# Memo

**Re:** SP-001292-2021: Nine Mile Corner King Soopers Site Plan Review
MPA-001291-2021: Nine Mile Corner Amd. No. 2 Minor Plat Amendment

Planning Redlines
1st Review
Shannon Moeller, Senior Planner
smoeller@erieco.gov

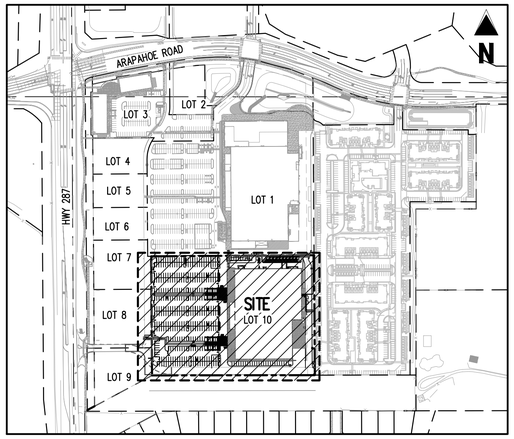
Staff counts 404, please coordinate across all sheets

4 van shown

Add PHARMACY STACKING REQUIRED / PROVIDED | 4 / 4

## NORTH ELEVATION

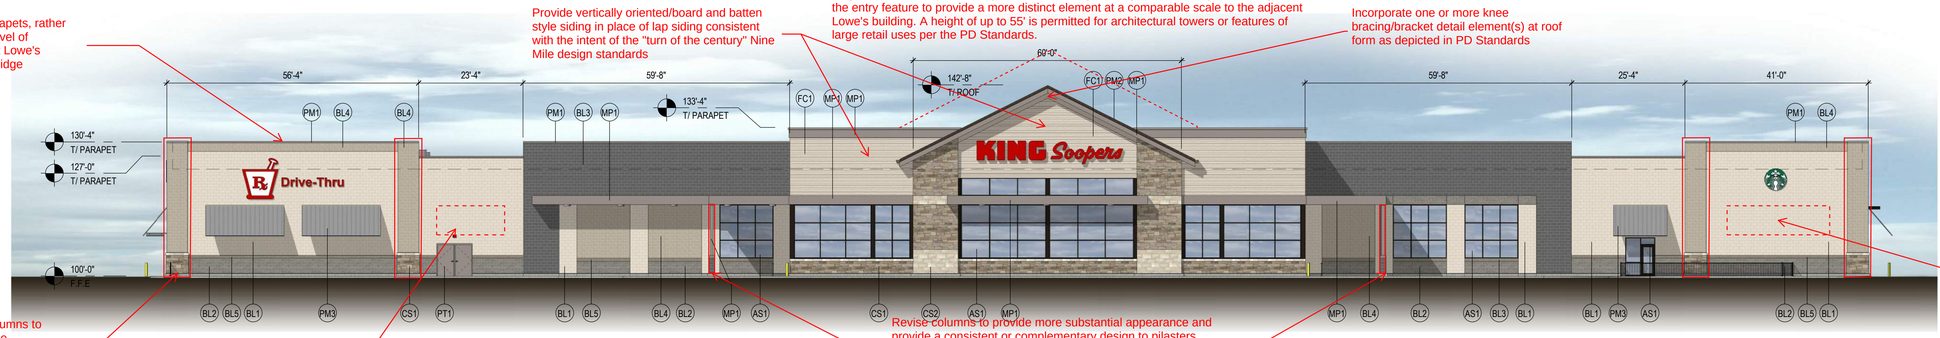
Provide decorative cornice on all parapets, rather than plain cap, to provide a similar level of architectural detailing to the adjacent Lowe's building and King Soopers at Vista Ridge

# WEST ELEVATION

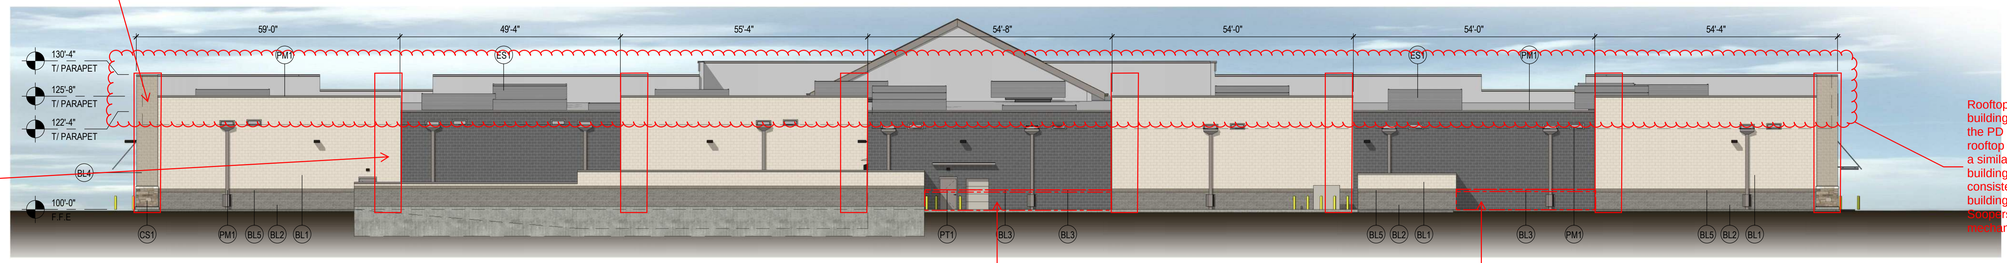
Provide pilasters on rear of building to meet PD Standards consistent with the Lowe's on adjacent lot and with the King Soopers at Vista Ridge

Rooftop screening is to be an integral part of the building design per UDC Section 10.6.4.G.6 and the PD standards require parapet walls to conceal rooftop mechanical equipment. Utilize parapets at a similar height and design on the back of the building as the other sides to screen mechanical, consistent with the recently approved Lowe's building in Nine Mile Corner and with the King Soopers in Erie at Vista Ridge. Dash locations of mechanical units beyond.

# EAST ELEVATION

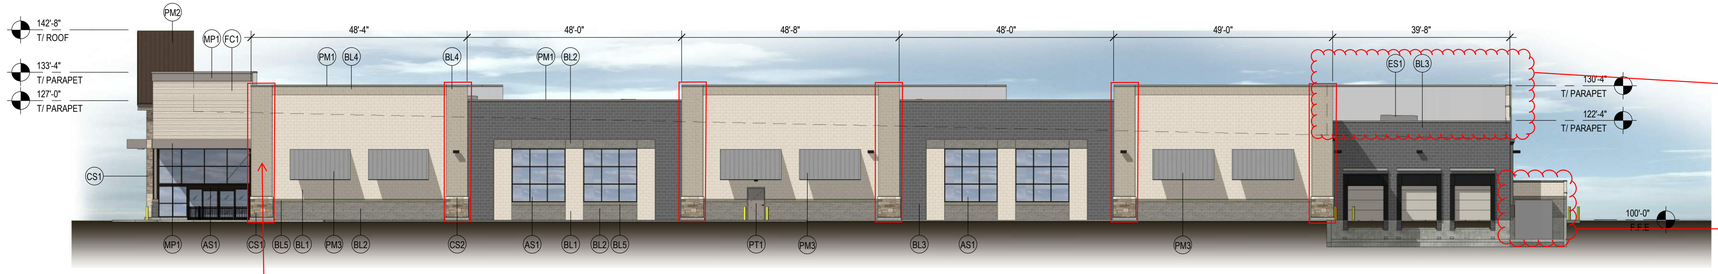
Provide stone wainscot at base or propose an alternative.

Provide stone wainscot at base or propose an alternative.

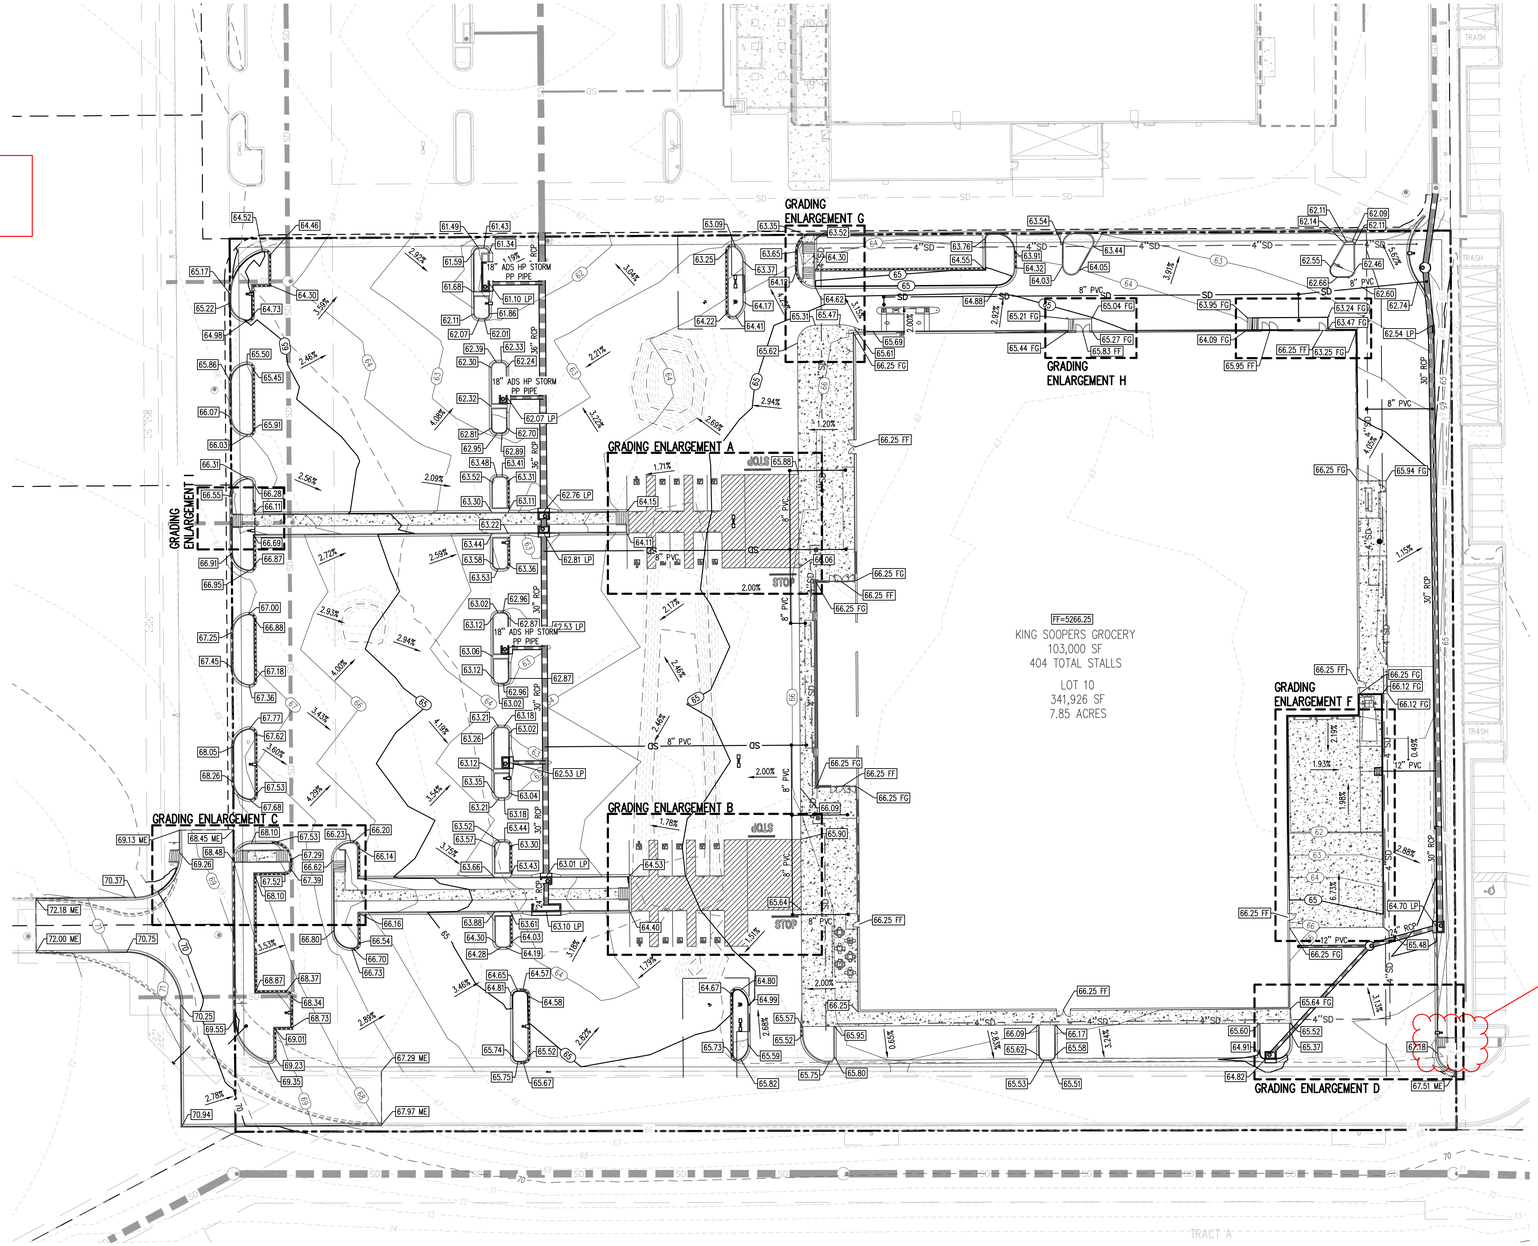
Please include:
Top of Foundation Elev
Elev of Any High Points
Lot Corner Elev
